CUMBERLAND
CITY COUNCIL

MEMORANDUM

Subject: Burnett St, Merrylands Urban Design Framework

Figure 2: Risk map of the area at 1% AEP flood event (predominantly Low risk)

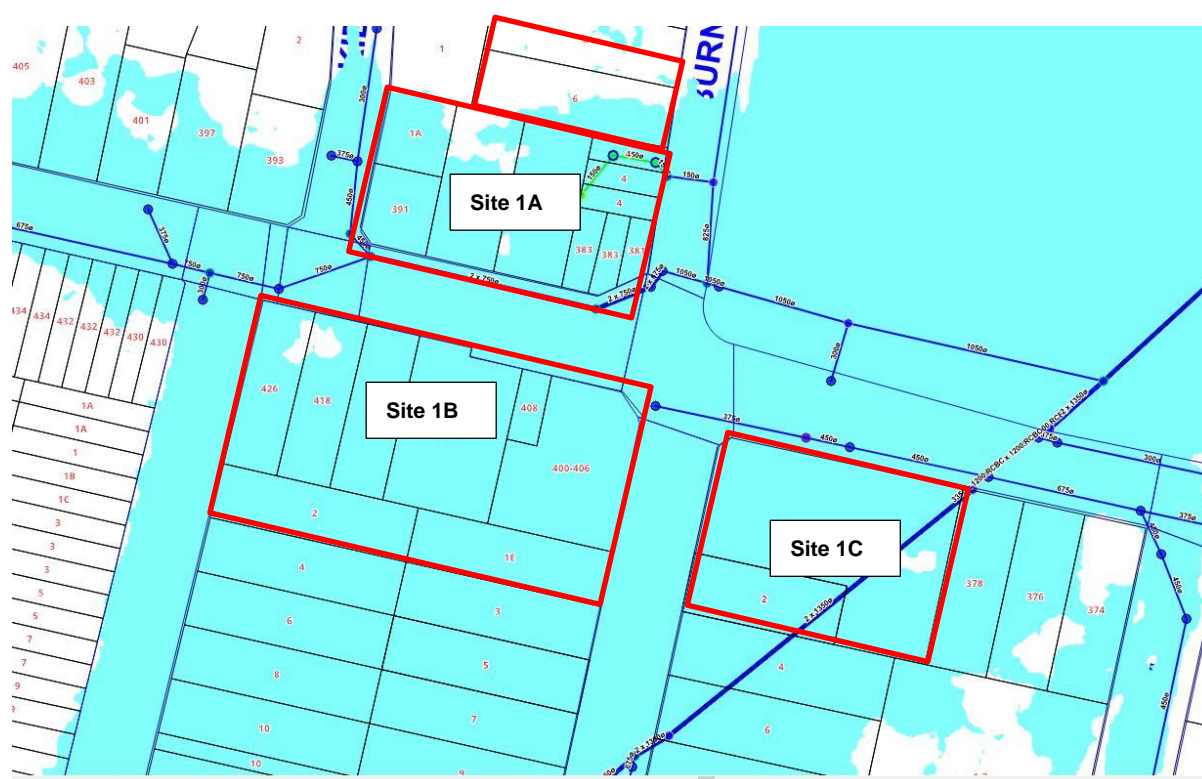
The site possesses mainly low to medium risk (figure 2 and 3) and almost entirely a flood fringe (figure 4). Council's map shows that Merrylands and Fowler Road are the major overland flow path at 1% AEP (figure 5). The flood depth within the sites is generally less than 100mm (figure 6). Council available flood map shows that the high risk and high hazards at Probable Maximum Flood (PMF) events are along the Merrylands Road and Fowlers Road (figure 7).

The available flood study and the maps indicates that the area is affected by 1% AEP flood and predominantly a flood fringe. The flood risk and flood hazard associates with the sites are predominantly low and the flood depth across the sites are less than 100 mm.

Figure 3: Risk map of the area at 1% AEP flood event (medium risk)

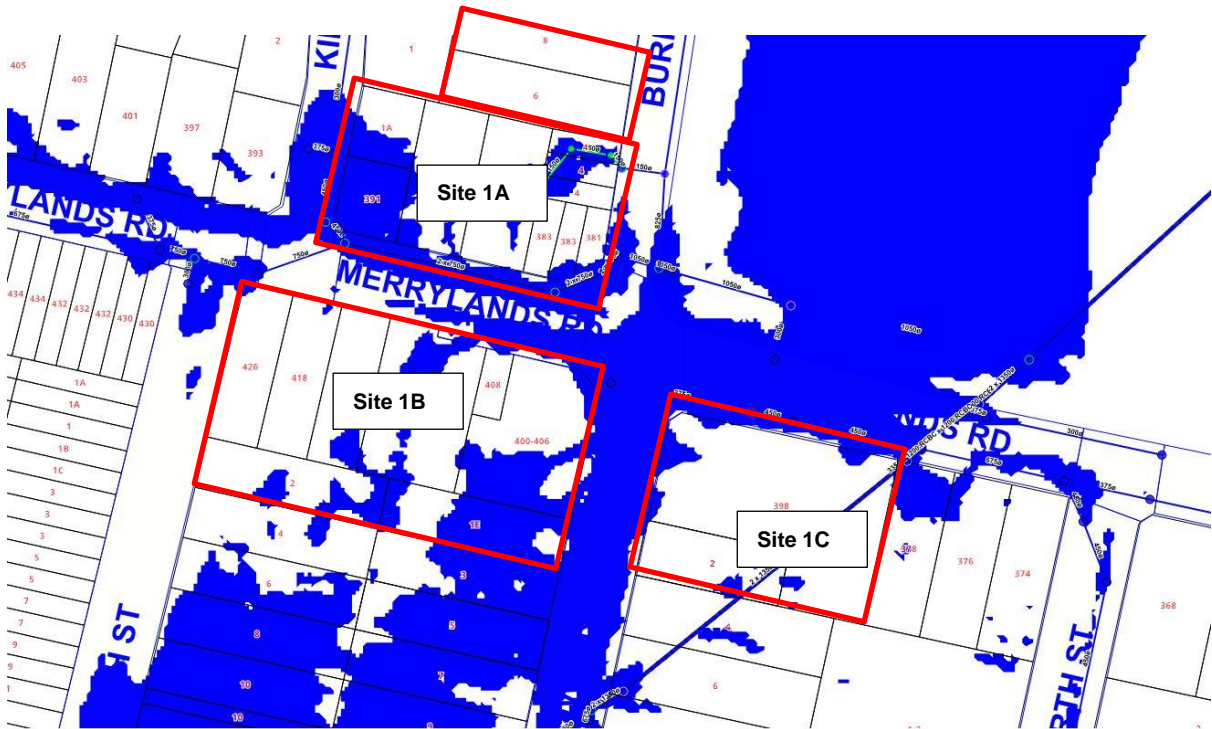
Council has determined that a part of the subject sites is within medium to high risk and patches of the sites are flood storage area, therefore, a CDC cannot be administered on these sites.

Figure 5: Overland flow path (1% AEP) along the Merrylands Road and Fowler Road

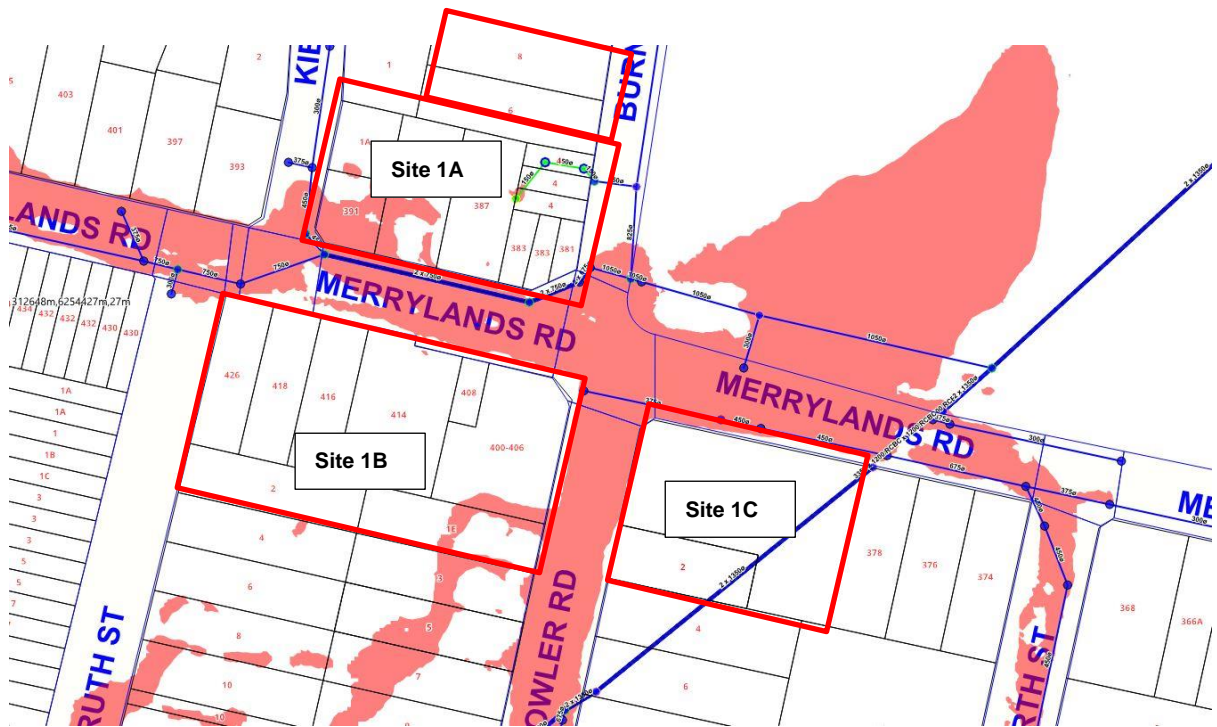
Due to the rezoning, there will be increased number of occupants and public assets within the redeveloped area, therefore an updated emergency evacuation and response plan must be prepared by a suitably qualified engineer and made available for the future occupants of the sites. The map shows that the Merrylands road and Fowler roads are the major overland flow path with high risk and high hazard.

However, the flood related development controls still apply to the new development in the subject sites where all the habitable area shall be 0.5m above the maximum 1 % AEP flood level at the upstream side of the structure. Minimum non-habitable floor levels including garages shall be 0.15m above the maximum 1 % AEP flood level at the upstream side of the structure. The crest of the entry to the basement carpark must located at 0.15m above the maximum 1 % AEP flood level at the site.
